**MONTGOMERY COUNTY HISTORIC PRESERVATION COMMISSION**  
**STAFF REPORT**

<b>Address:</b>	102 East Kirke Street, Chevy Chase	<b>Meeting Date:</b>	9/17/2025
<b>Resource:</b>	Outstanding Resource <b>Chevy Chase Village Historic District</b>	<b>Report Date:</b>	9/10/2025
<b>Applicant:</b>	Britt & Will Williams (Luke Olson, Architect)	<b>Public Notice:</b>	9/3/2025
<b>Review:</b>	HAWP	<b>Tax Credit:</b>	n/a
<b>Permit No.:</b>	1067931 REVISION#3	<b>Staff:</b>	Dan Bruechert
<b>Proposal:</b>	Revisions to previously approved patio and swimming pool.

The applicant proposes to revise the approved design by reducing the size of the approved swimming pool and reduce the approved patio in response to Chevy Chase Village requirements.

DRAINAGE PLAN  
102 E. KIRKE STREET  
LOTS 14-15 & PART OF LOT 16, BLOCK 34  
SECTION No. 2 CHEVY CHASE  
BETHESDA (7th) ELECTION DISTRICT  
MONTGOMERY COUNTY, MARYLAND

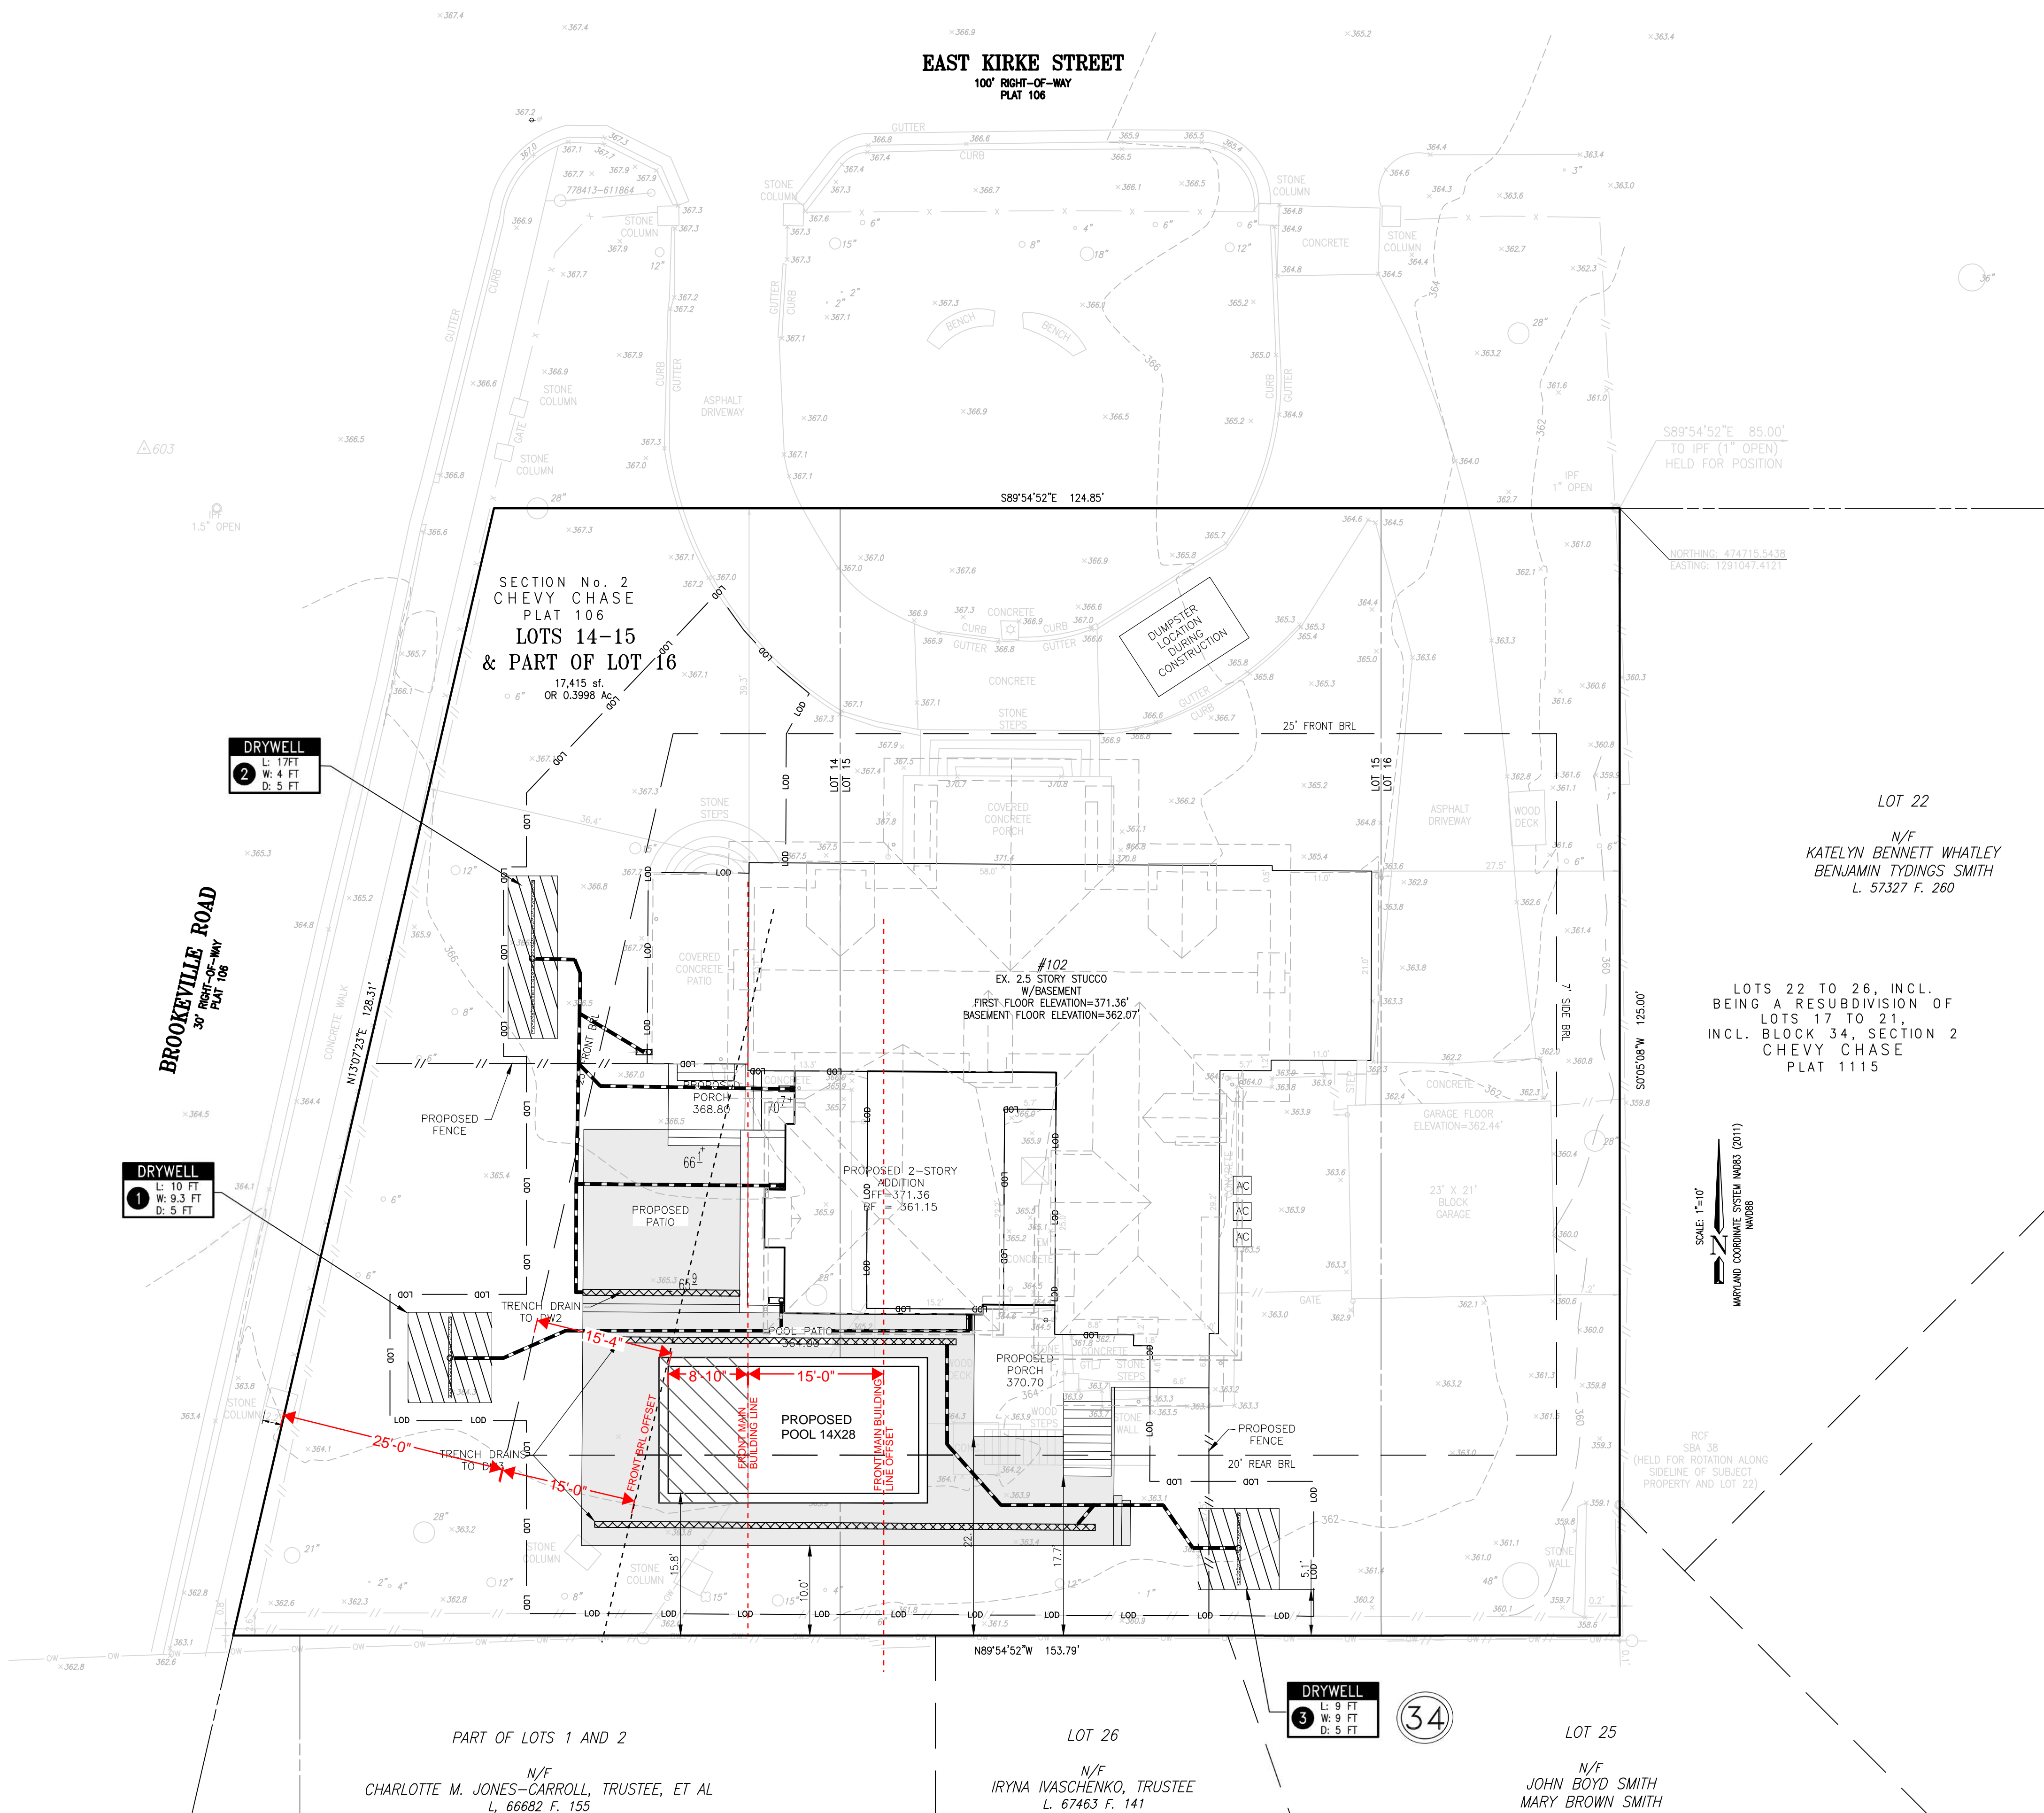
The approved HAWP included the construction of a swimming pool in the southwest corner of the property and an associated patio surrounding it. In the Chevy Chase Village permit review, the Village determined that the pool violated the requirement that pools be set back 15' (fifteen feet) beyond the 25' (twenty five foot) front yard setback, and because the Brookeville Rd. is considered a 'front' under their zoning ordinance, the pool needed to be relocated. Additionally, the patio area to the south of the pool had to be reduce so that it maintained the required 10' (ten foot) clearance from the rear lot line. The result of these changes is a reduction of approximately 260 ft<sup>2</sup> (two hundred sixty square feet) of impervious surface at the subject property. The approved materials will not be changed.

Staff finds the proposed reduction in overall lot coverage is a positive change that will only help reinforce the district's character-defining open, park like setting. The proposed materials for the patio and pool

**Figure 2: South elevation showing the location of the proposed window and door replacements.**

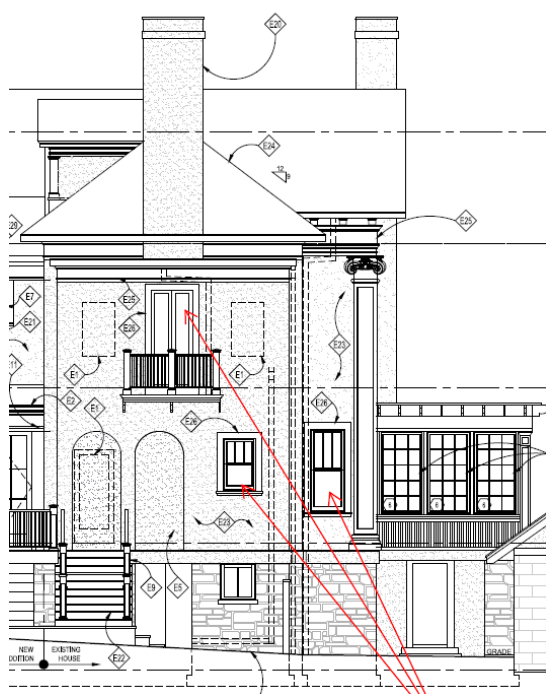
The second floor French Doors (Door #3), shown in *Figure 2*, above, are wood with each door divided up into three lights. The doors show signs of warping and have allowed a significant amount of water infiltration to the point that the interior floors adjacent to the French Doors show substantial damage.

Detailed specifications for the replacement doors were not included with the application materials. The application narrative states the proposed door will be a clad wood door to match the existing configuration in SDL divisions.

On the south and east elevations, the applicant proposes to remove and replace five existing wood windows (identified as windows 1, 2, 3, 7, and 8 in the application). Three windows are on the east elevation of the existing rear-L (see *Figure 3*, below). One of the windows is on the south elevation of the main house mass and the last window is on the south elevation of the rear ell (see *Figure 2*, above). These windows are not visible from the public right-of-way.

Because the existing door is not at all visible from the public right-of-way and it shows damage and deterioration, Staff finds its removal is supported under the *Design Guidelines*. Staff further finds an aluminum clad door consistent with the appearance of the approved but uninstalled clad windows on the south and east elevations is appropriate under 24A-8(b)(2) and (d) and the *Design Guidelines*. Staff recommends the HPC add a condition to the approval of this HAWP that detailed door specifications need to be submitted for review and approval before issuance of the final permit documents. Final approval authority can be delegated to Staff to verify the replacement door is consistent with the configuration and dimensions of the existing door.

**Figure 3: Eastern elevation showing the proposed replacement windows.**

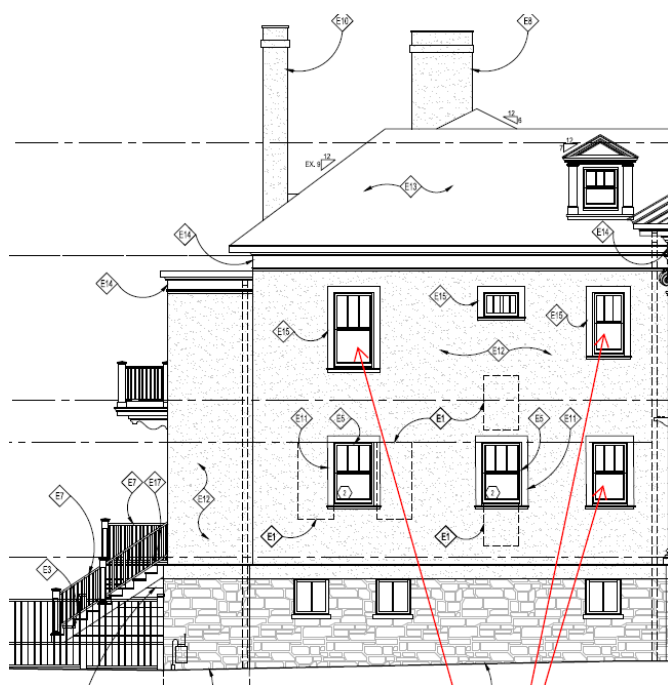
The applicant proposes to install replacement clad wood windows that match the configuration and

dimensions in the existing openings. The application does not specify the reason for the window replacement beyond providing a more uniform level of materiality and detailing on the rear of the house. Staff notes that the HPC has already approved the removal, reconfiguration, and replacement of several windows in the rear ell in the original HAWP.

As discussed in the previous HAWP revision, the *Design Guidelines* state windows not visible from the public right-of-way, as is the case with the windows under consideration in this HAWP revision, should be reviewed under lenient scrutiny, with the exception that windows on Outstanding Resources should be reviewed under strict scrutiny. Under this analysis, windows not visible from the public right-of-way on Outstanding Resources still need to be evaluated under strict scrutiny. In the original HAWP, the Staff recommended the HPC approve the window relocation based in part on the lower level of architectural detail and design significance of the rear ell and because they were not at all visible from within the historic district. The rear ell lacks the columns, decorative modillion cornice, and detailed window trim found on the main house massing. As before, Staff supports the window removal on the east elevation and south elevation of the east ell under 24A-8(b)(2), the *Design Guidelines*, and Standard 2.
